DART AEROSPACE LTD		Work Order: 97860
Description: Crosstube Assembly, Mid Aft		Part Number: D206-667-247TRN
Inspection Dwg: D206-667-247 Rev: A		Page 1 of 2

DART AEROSPACE LTD HAWKESBURY, ONTARIO, CANADA		REV. A
DRAWING NO.	D206-667-247	SHEET 1 OF 4
TITLE	CROSSTUBE ASS'Y (206L MID AFT)	SCALE
COPYRIGHT © 2010 BY DART AEROSPACE LTD		NTS
THIS DOCUMENT IS PRIVATE AND CONFIDENTIAL AND IS SUPPLIED ON THE EXPRESS CONDITION THAT IT IS NOT TO BE USED FOR ANY PURPOSE OR COPIED OR REPRODUCED IN ANY MANNER WITHOUT WRITTEN PERMISSION FROM DART AEROSPACE LTD.

DRAWING NO. D206-667-247	TITLE CROSSTUBE ASS'Y (206L MID AFT)	REV. A	DART AEROSPACE LTD ENGINEERING ORDER		D.E.O. NO. D206-667-247-A-1	SHEET NO. SHEET 1 OF 1	SCALE NTS
DRAWN 97	CHECKED ASS	MFG. APPR. KTB	APPROVED JMP		DE APPR. H		
DATE 11.07.15	DATE 11.07.20	DATE 11.07.21	DATE 11/07/21		DATE 11.07.21

REPLACE MAGNOBOND WITH PROSEAL.

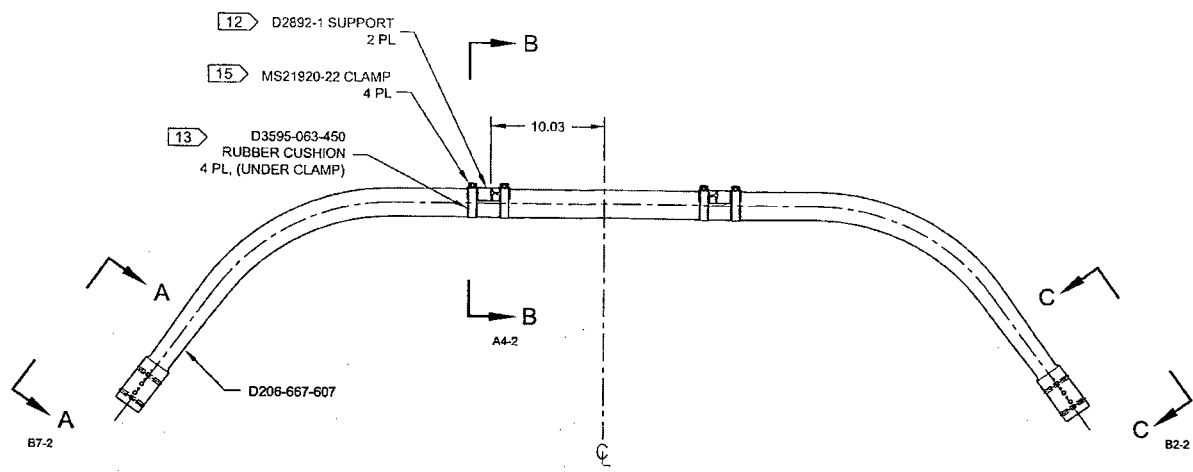
IS:

Item	Qty -247	Part Number	Description
9	A/R	PROSEAL 890 B-2	SEALANT, AMS-S-8802 CLASS B-2

WAS:

9	A/R	MAGNOBOND 6398	ROCKWELL SPECIFICATION RBO-120-023 ADHESIVE (TEXTRON/BELL SPEC. 299-947-100, TYPE II, CLASS 2 ADHESIVE)
---	-----	----------------	---

NOTE 12 & 15, SHEET 1 IS AMENDED AS FOLLOWS:

- 12) TO INSTALL D2892-1 SUPPORT: ABRABE MATING SURFACE OF SUPPORT AND CROSSTUBE WITH 180-GRIT SANDPAPER AND REMOVE RESIDUE WITH MEK (OR EQUIVALENT). APPLY A 0.04" TO 0.07" THICK LAYER OF PROSEAL 890 CLASS B-2 (OR AMS-S-8802 CLASS B-2) SEALANT TO MATING SURFACE OF SUPPORT.
- 15) TORQUE CLAMPS 80 TO 100 IN-LB. ENSURE AT LEAST 1.5 THREADS SHOWING IN SAFETY AND THAT NUT HAS NOT BOTTOMED-OUT AFTER TORQUING. **PRIOR TO PACKAGING, RE-CHECK TORQUE ON CLAMPS AFTER PROSEAL 890 SEALANT HAS CURED FOR 72 HOURS.**

- 12) INSTALL D2892-1 SUPPORT USING 0.03" TO 0.06" THICK LAYER OF MAGNOBOND 6398 PER QSI 015. LET CURE FOR 12 HOURS AFTER INSTALLATION AND PRIOR TO PACKAGING.
- 15) TORQUE CLAMPS 80 TO 100 IN-LB. ENSURE AT LEAST 1.5 THREADS SHOWING IN SAFETY AND THAT NUT HAS NOT BOTTOMED-OUT AFTER TORQUING.
